**RESOLUTION NO. 47-2022**

**CONDITIONALLY APPROVING THE SCHEMATIC DESIGN FOR THE TRANSBAY BLOCK 3 PARK AND STREETScape IMPROVEMENTS PROJECT; ADOPTING ENVIRONMENTAL FINDINGS PURSUANT TO THE CALIFORNIA ENVIRONMENTAL QUALITY ACT; AND PROVIDING NOTICE THAT THIS ACTION IS WITHIN THE SCOPE OF THE TRANSBAY TERMINAL / CALTRAIN DOWNTOWN EXTENSION / REDEVELOPMENT PROJECT FINAL ENVIRONMENTAL IMPACT STATEMENT / ENVIRONMENTAL IMPACT REPORT (“FEIS/EIR”), A PROGRAM EIR, AND IS ADEQUATELY DESCRIBED IN THE FEIS/EIR FOR PURPOSES OF THE CALIFORNIA ENVIRONMENTAL QUALITY ACT; TRANSBAY REDEVELOPMENT PROJECT AREA**

Exhibit A: The Schematic Design for the Transbay Block 3 Park and Streetscape Improvements Project

Exhibit B: Conditions of Approval

# RIGHT-OF-WAY SCOPE OF IMPROVEMENTS

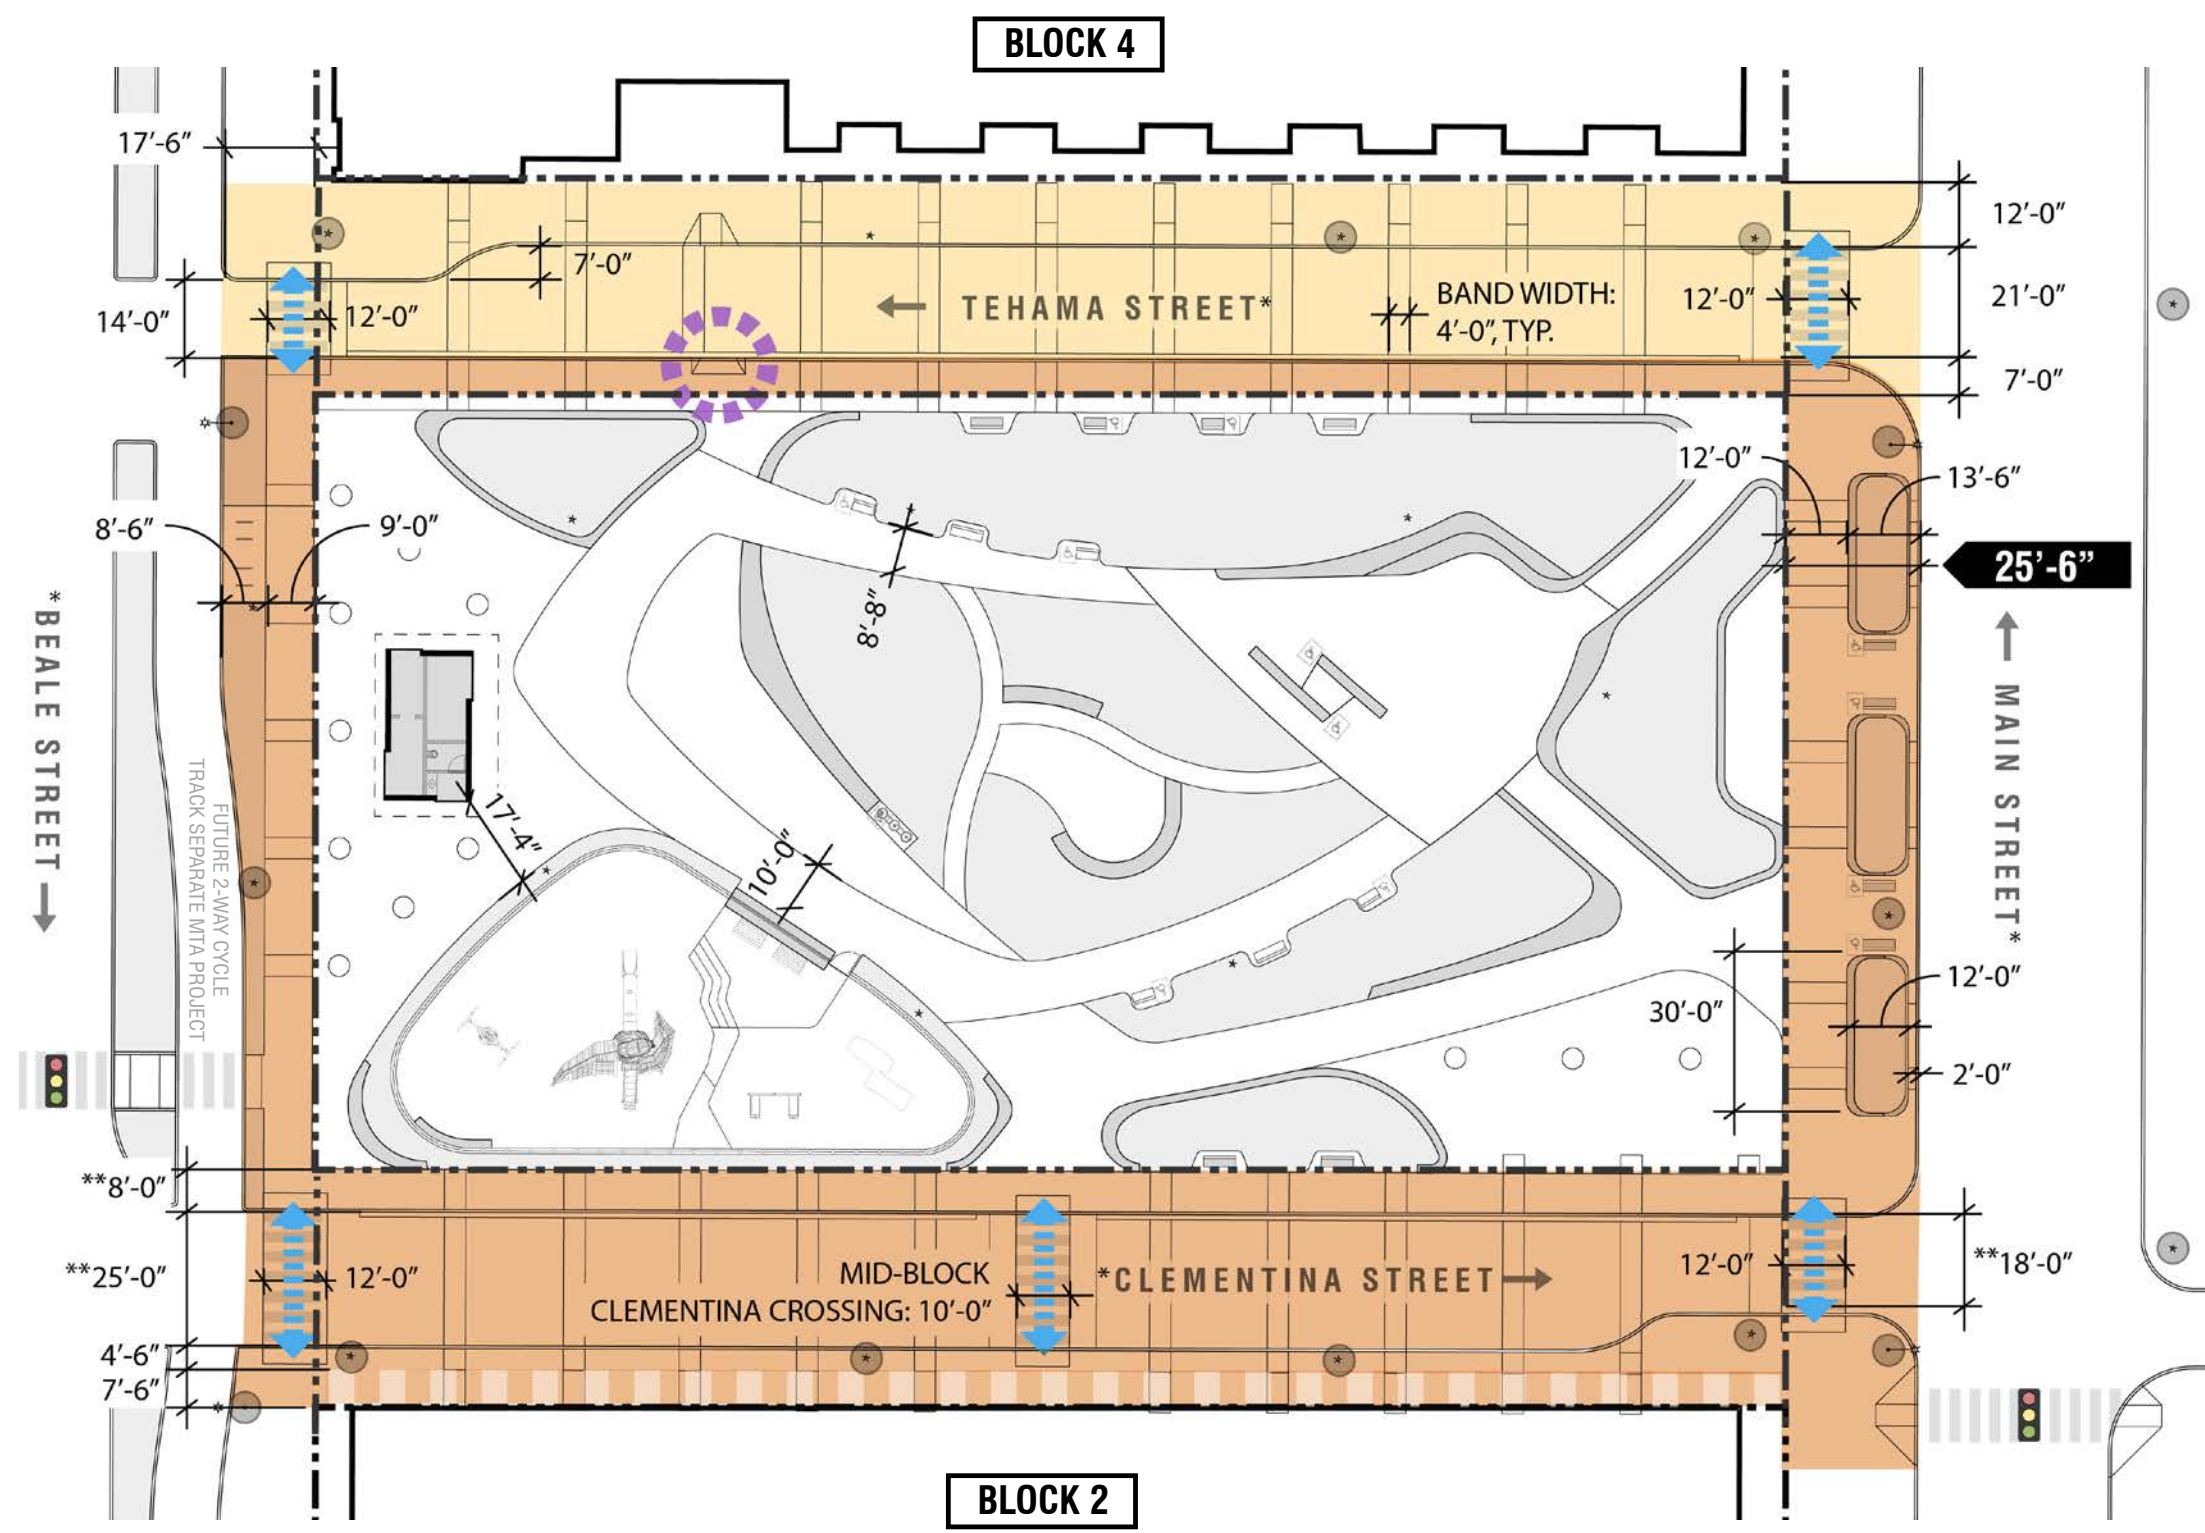
8. **Streetscape Configuration.**
  - a. SFPW shall continue to refine the design and materiality of streetscape improvements for Beale, Main, and Tehama Streets flanking the Park. Streetscape elements for Tehama, Clementina, Beale, and Main Streets are subject to change, pending subsequent City Department requirements.

- b. In the event that the final Construction typology for Transbay Block 2 triggers a change in fire code for emergency vehicle access to Clementina Street, the Clementina drive aisle width may be revised, and the sidewalk and street section shall be redesigned accordingly. For example, Clementina Street drive aisle width may be reduced by 4' overall (to allow for 12' wide northern sidewalk) if Block 2 construction type is confirmed to be Type I.

# STEWARDSHIP BUILDING - SITE PLAN

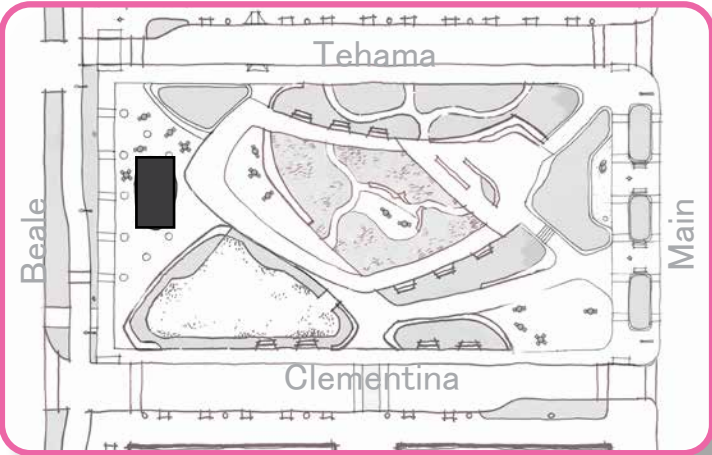
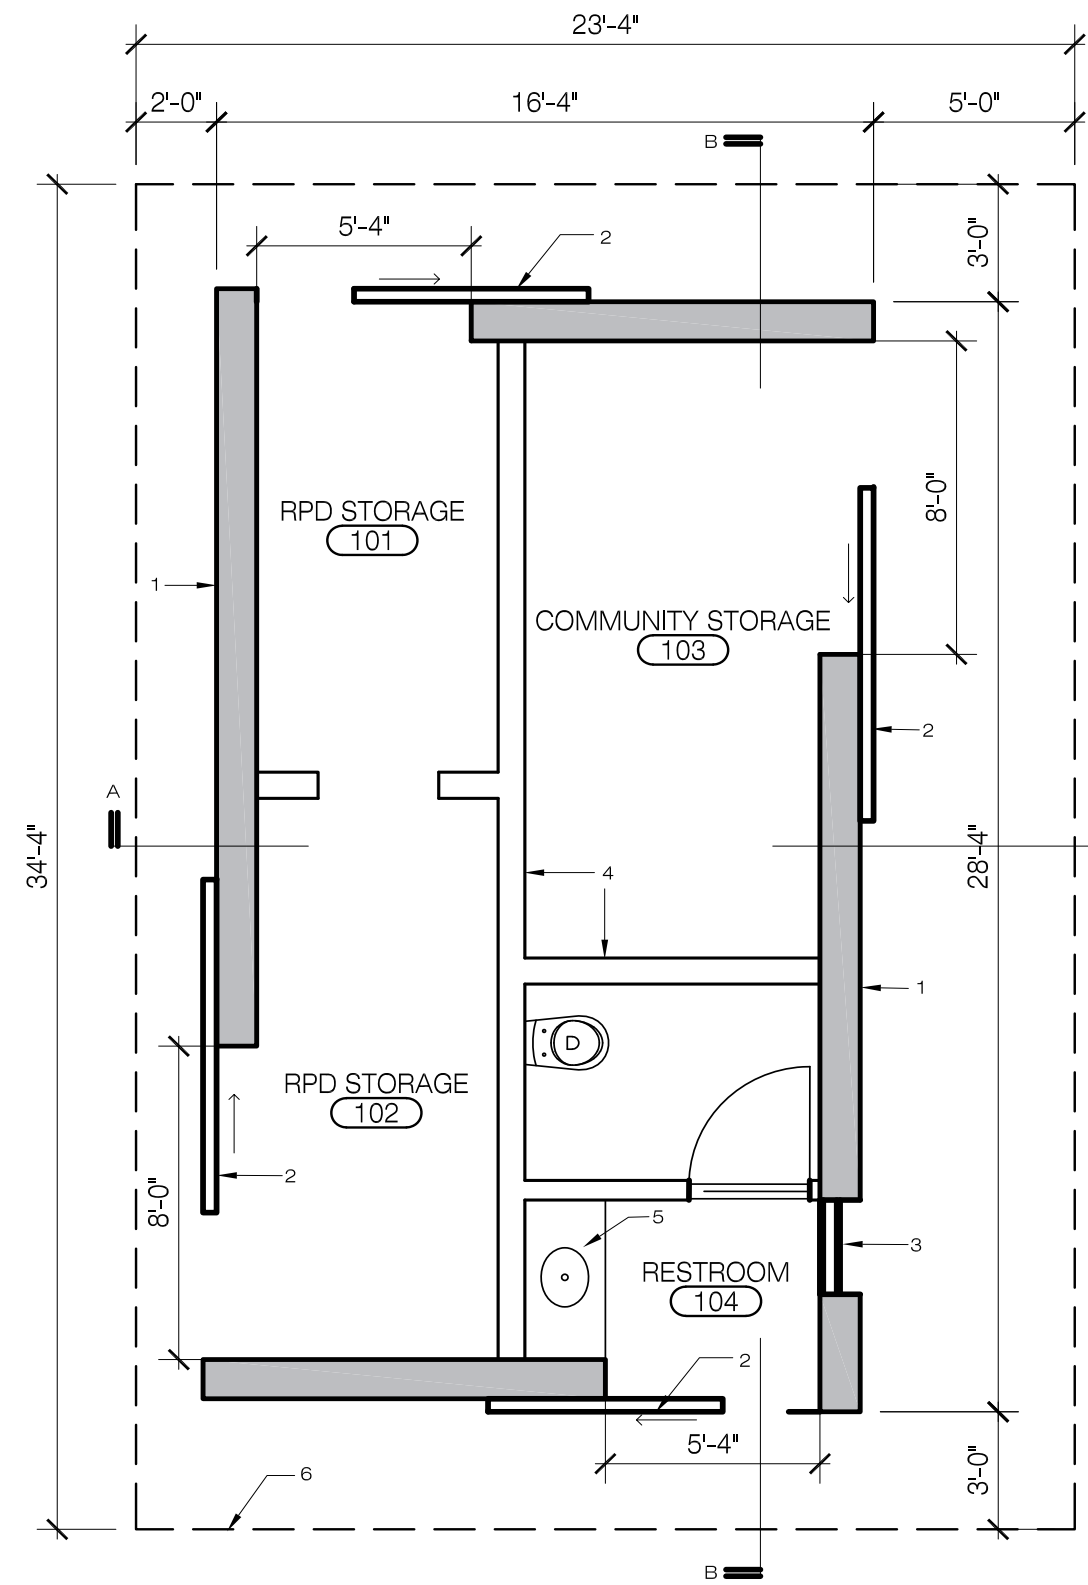
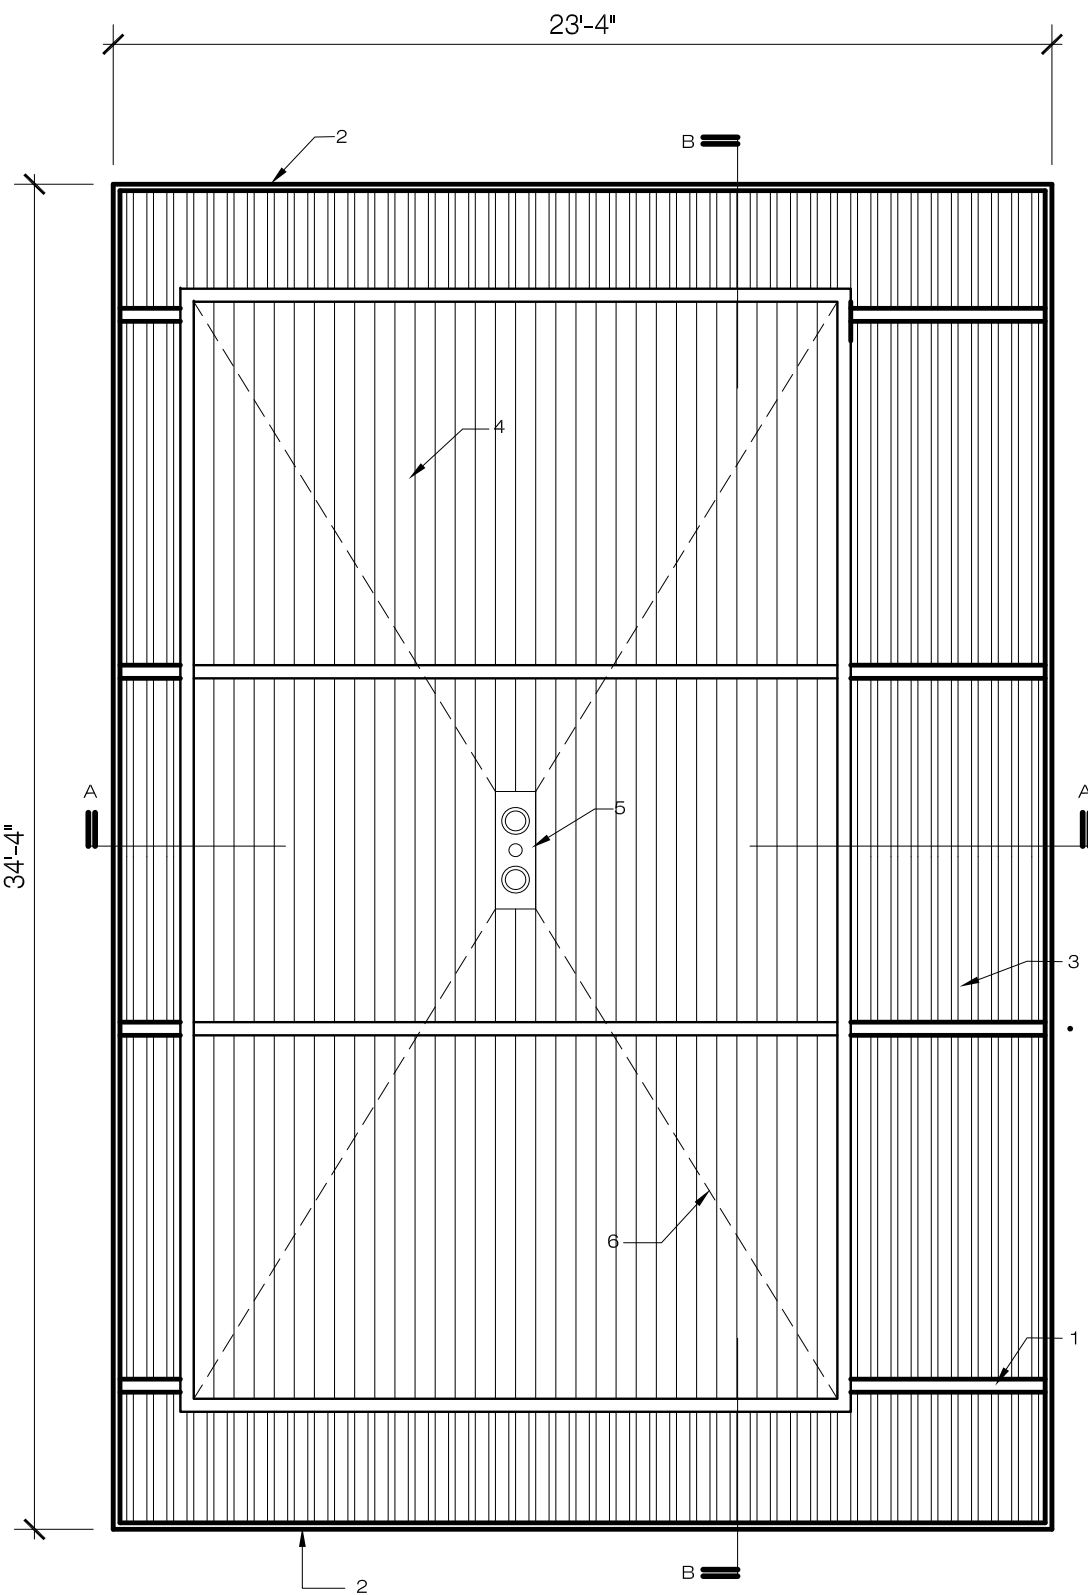
- 3. Architectural Plans.** The Design Development submittal shall include detailed Stewardship Building architectural plans, including to-scale plans, sections, elevations and details.

5. **Stewardship Building Materials & Samples.** Prior to construction bid and the general contractor procuring exterior materials, SFPW shall continue to develop and refine the Stewardship Building materials palette. SFPW shall request material manufacturer sales representative to provide at no cost to SFPW physical primary exterior materials samples for OCII and RPD staff review and approval. The materials palette must demonstrate durability, quality, color, variety, and visual interest along all exterior facades. Sustainable, locally-sourced and recycled materials are highly encouraged.

6. **Stewardship Building Architectural Mock-Up Scope.** Prior to construction bid document submittal and in advance of building materials purchasing by a general contractor, provide scope and plans for a Stewardship Building design mock-up, including primary building materials, color palette, wall systems, glazing and detail installation. OCII staff shall approve a) mock-up plans prior to mock-up construction, and b) include contract document specifications requiring a mock-up of materials, as per construction documents, and their application to be performed by a general contractor, after OCII staff's mock-up observations and prior to a general contractor's materials purchases and shipping.
